**GENOA CHARTER TOWNSHIP
PLANNING COMMISSION
PUBLIC HEARING
FEBRUARY 9, 2015
6:30 P.M.
AGENDA**

Attention:	Kelly Van Marter, AICP Assistant Township Manager and Planning Director
Subject:	DeWitt Radiator Addition – Site Plan Review #1
Location:	1275 Grand Oaks Drive – east side of Grand Oaks, south of Grand River Avenue
Zoning:	IND Industrial District

Attention:	Kelly Van Marter, AICP Assistant Township Manager and Planning Director
Subject:	Redevelopment of Livingston Commons Lot #4 – Site Plan Review #3
Location:	Southwest corner of Grand River Avenue and Latson Road
Zoning:	NR-PUD Non-Residential Planned Unit Development District

SHEET
C-2.3

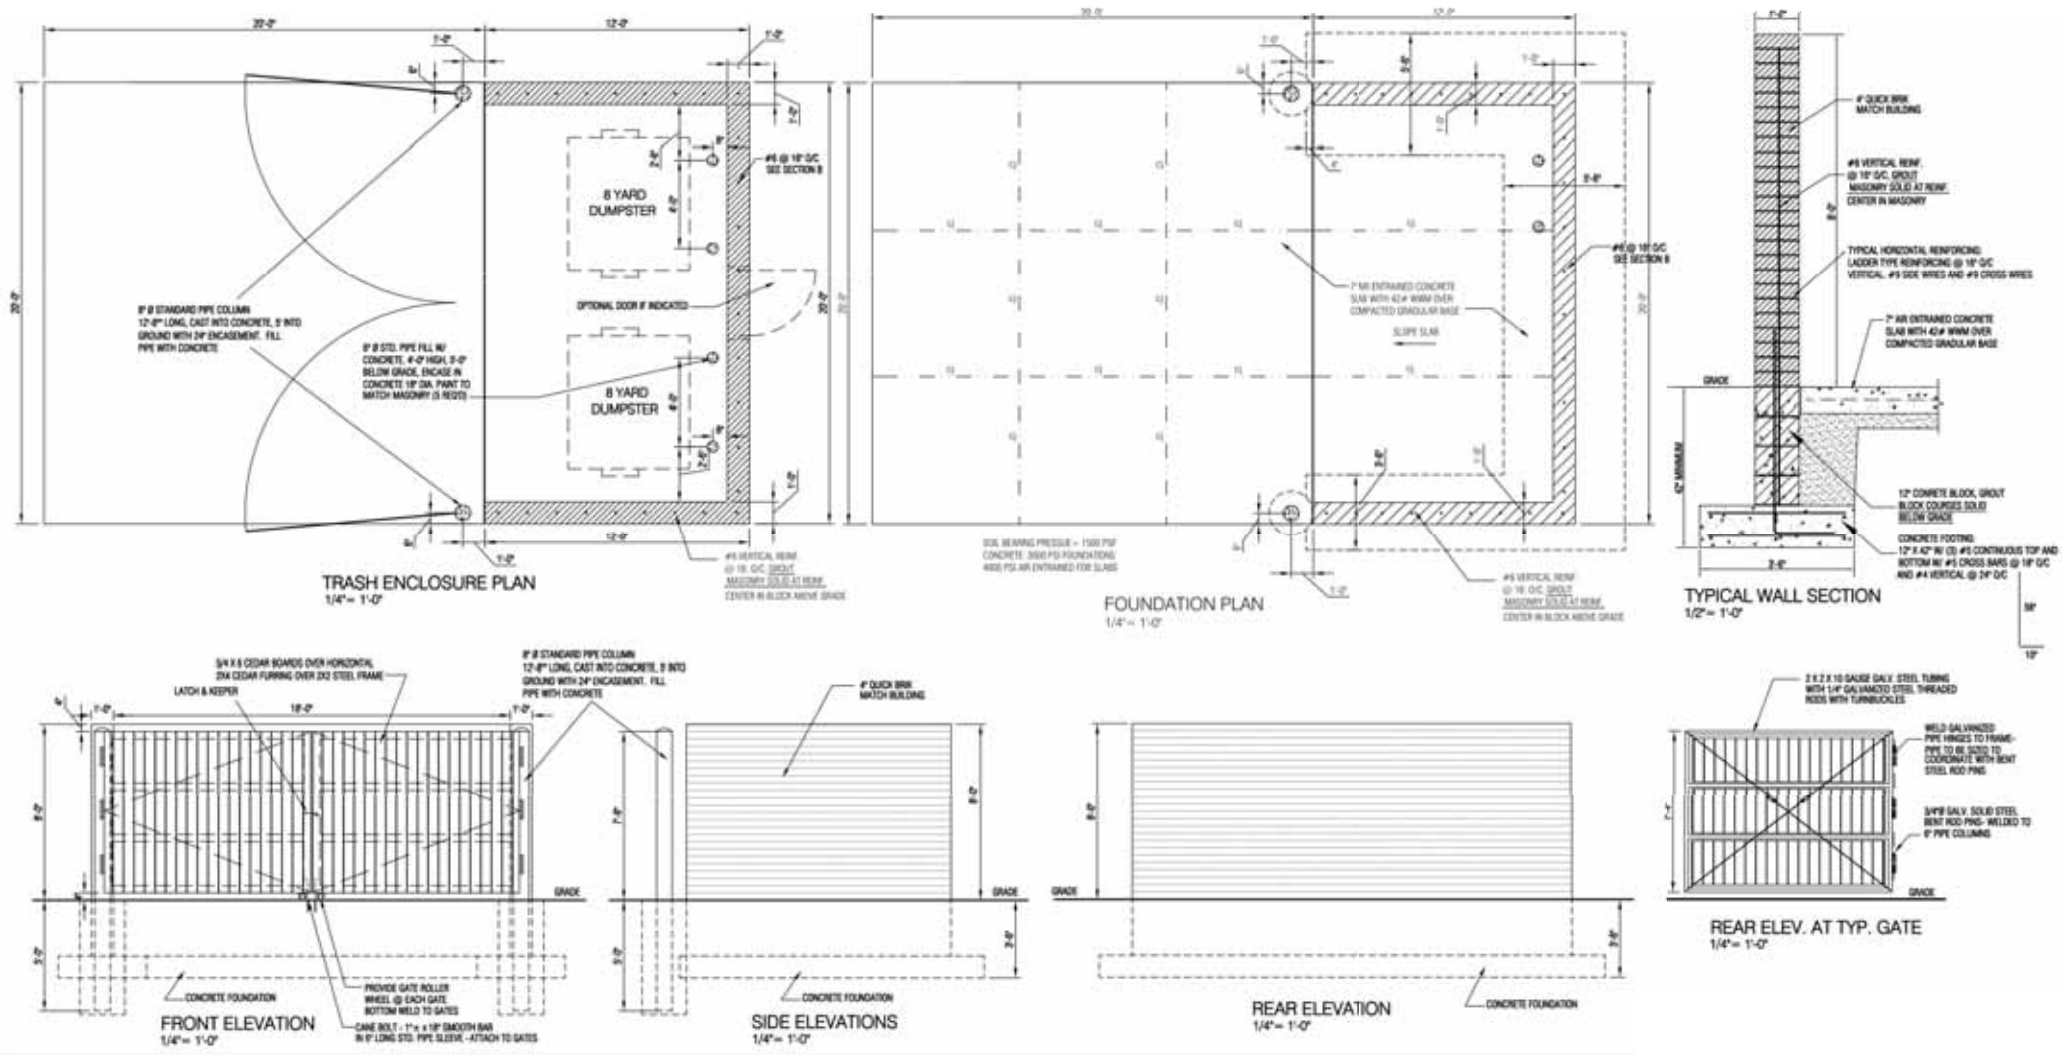
Details on Sheet C-2.3 identify the required concrete base pad and a masonry enclosure, which will match materials used on the building.

SHEET C-5.0

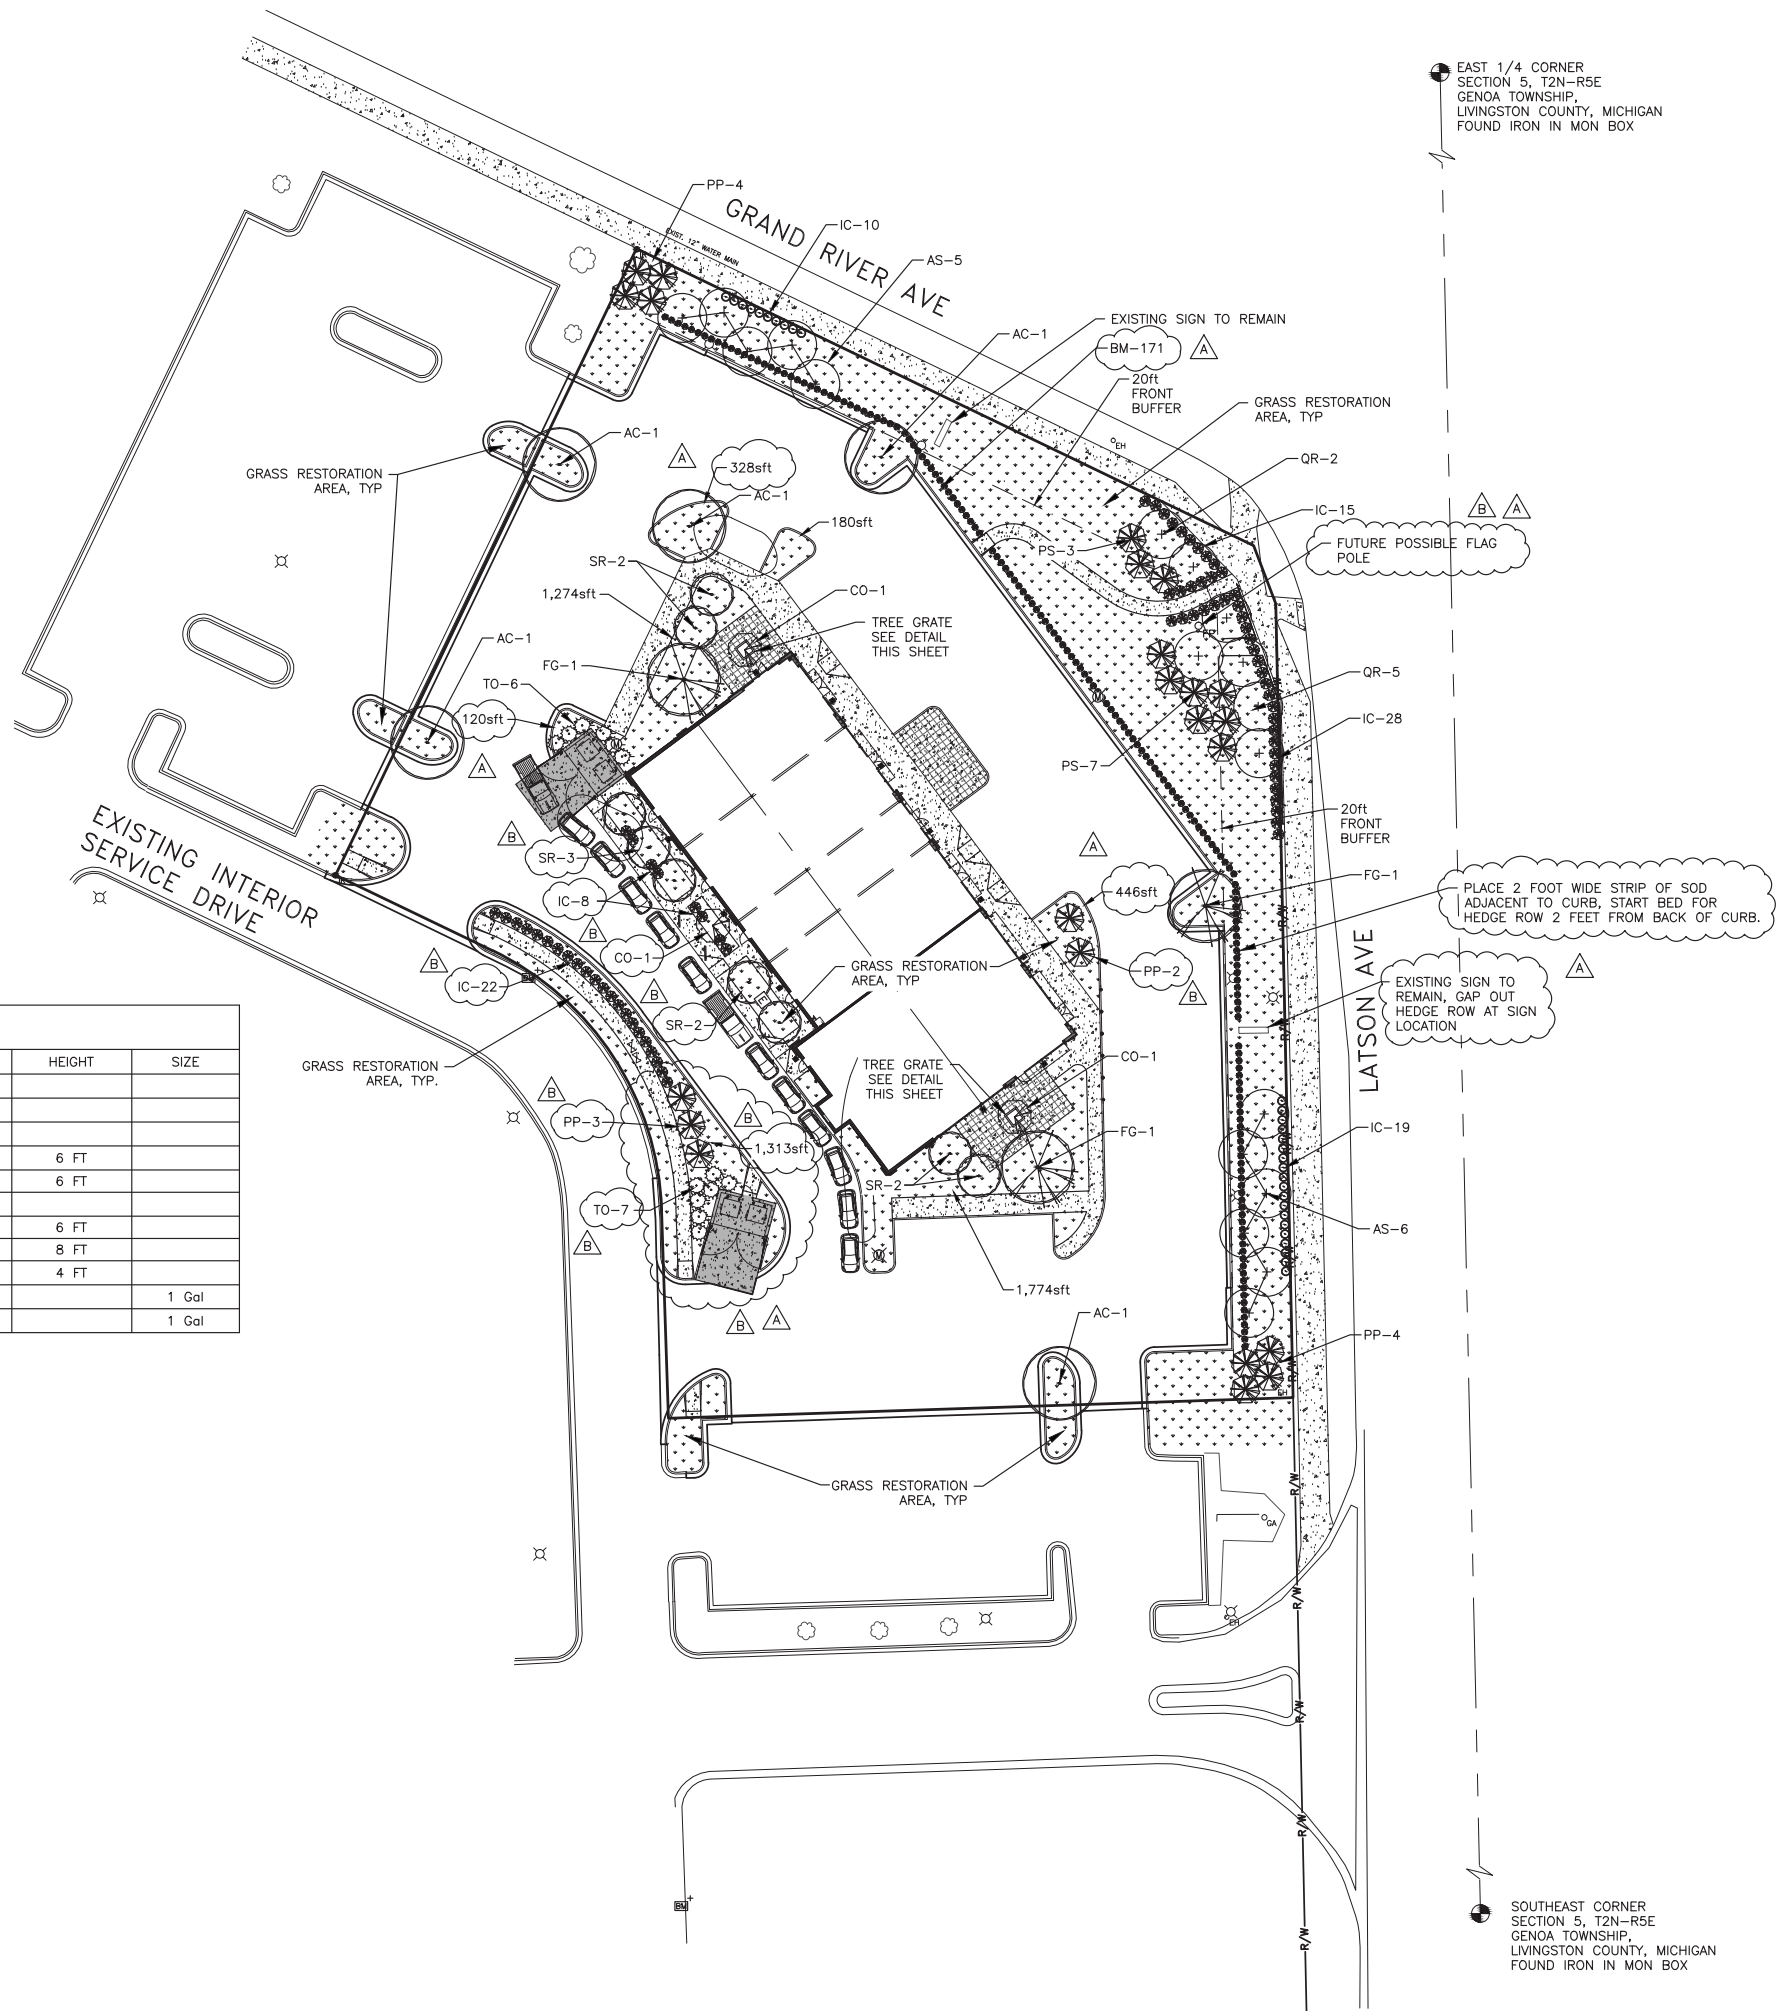
Our only additional comment is a discrepancy in the number of Colorado Blue Spruce between the plan (13) and table (23) that must be corrected on Sheet C-5.0.

SHEET C-6.0

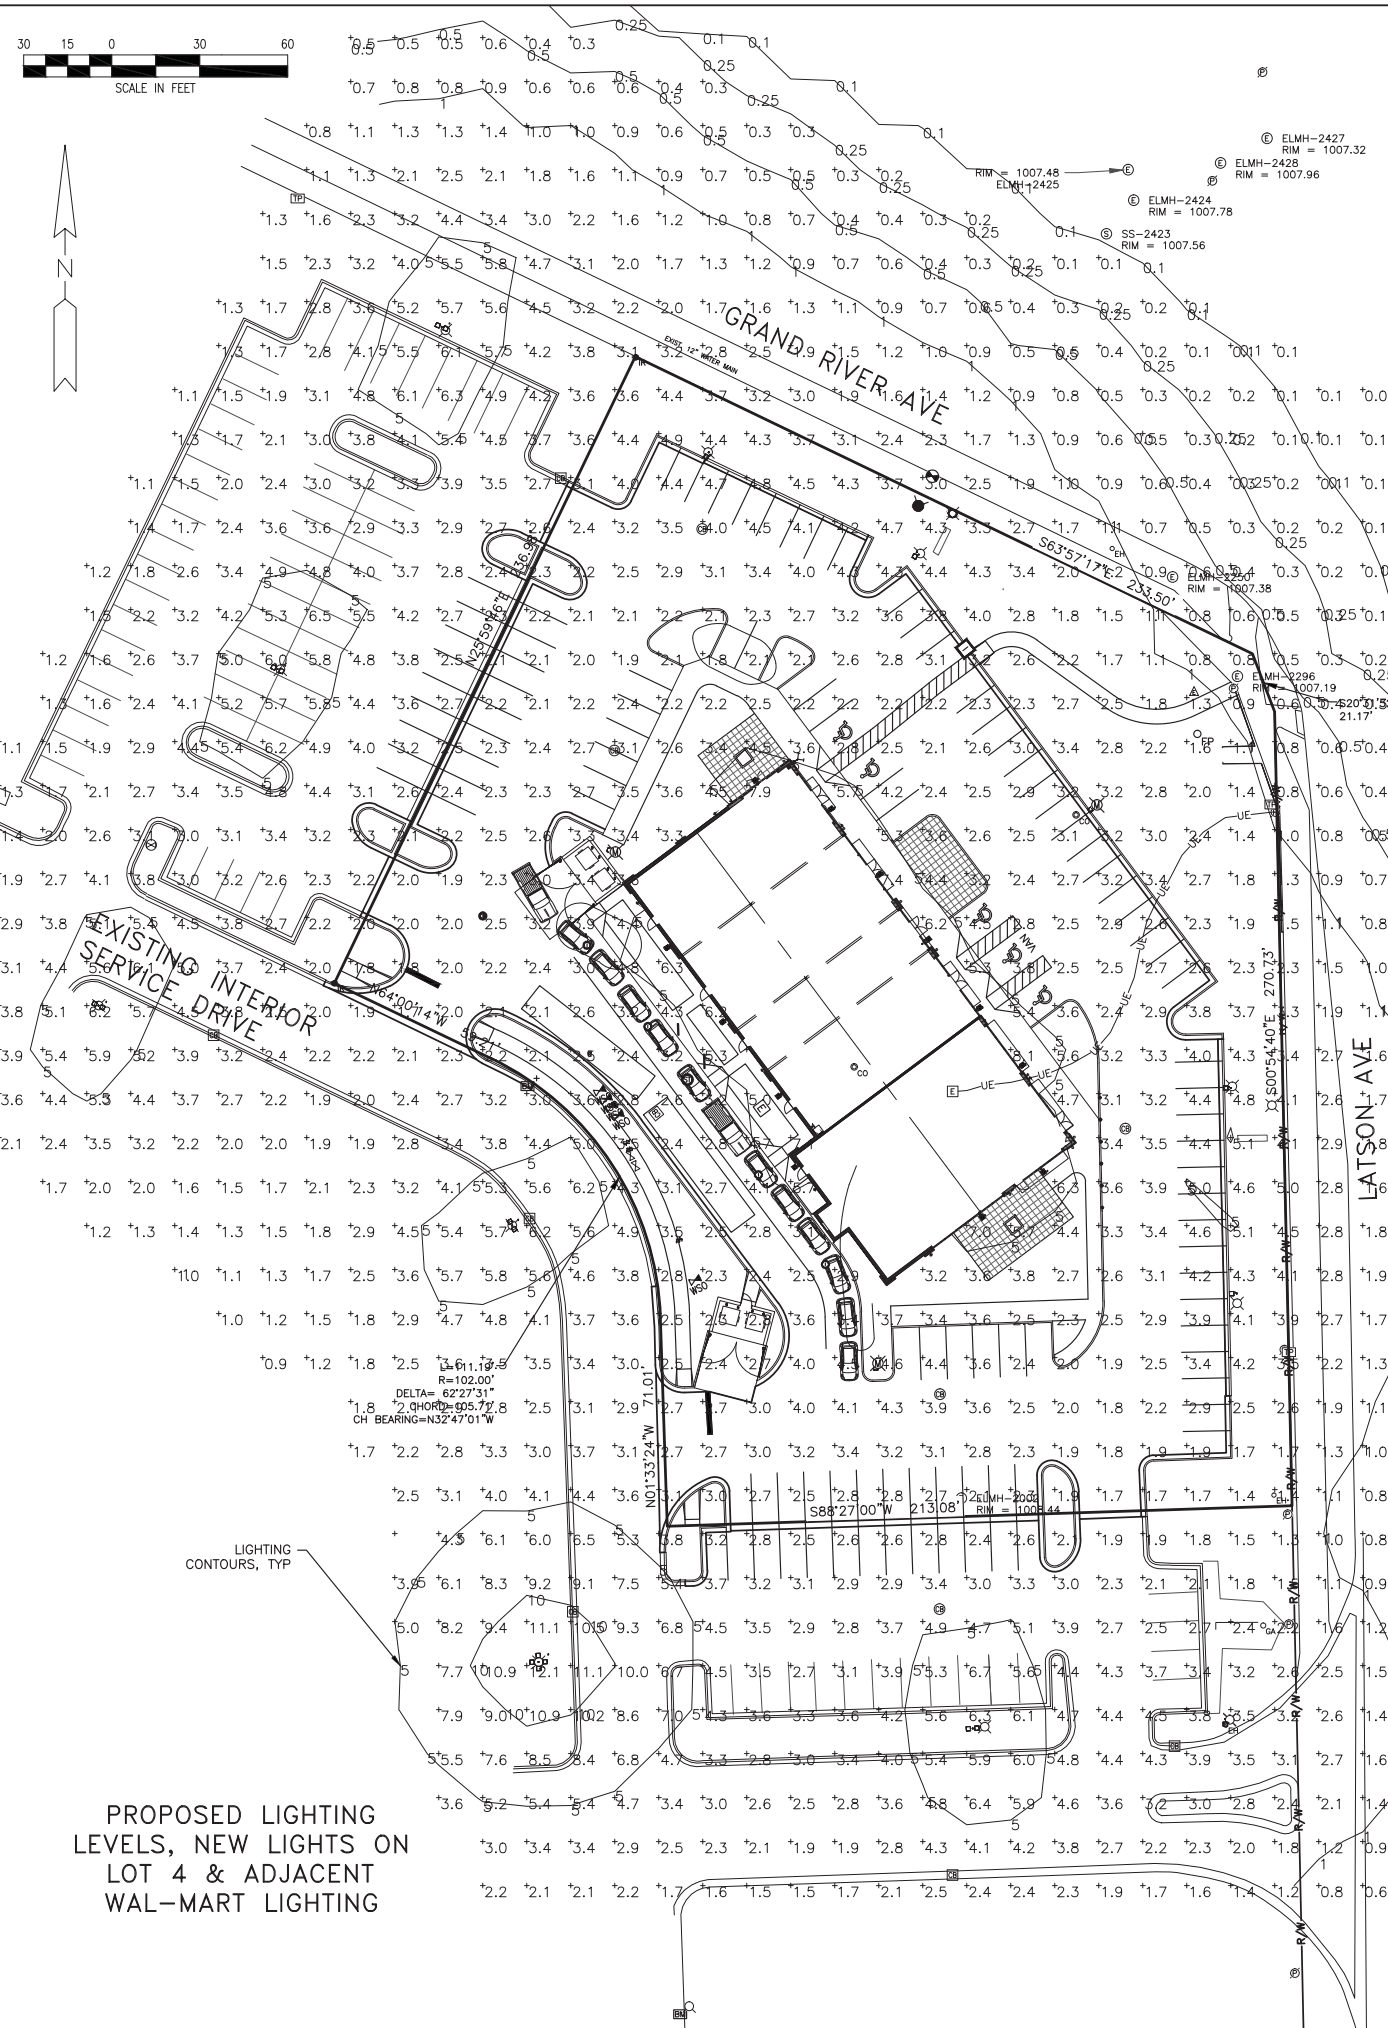
- 9. Exterior Lighting.** The submittal includes a lighting plan (Sheet C-6.0), which proposes the installation of 3 new light poles, 4 new light fixtures on existing poles and 12 wall mounted fixtures. The details and photometric readings on Sheets C-6.0 and C-6.1 are all in accordance with the requirements of Section 12.03.
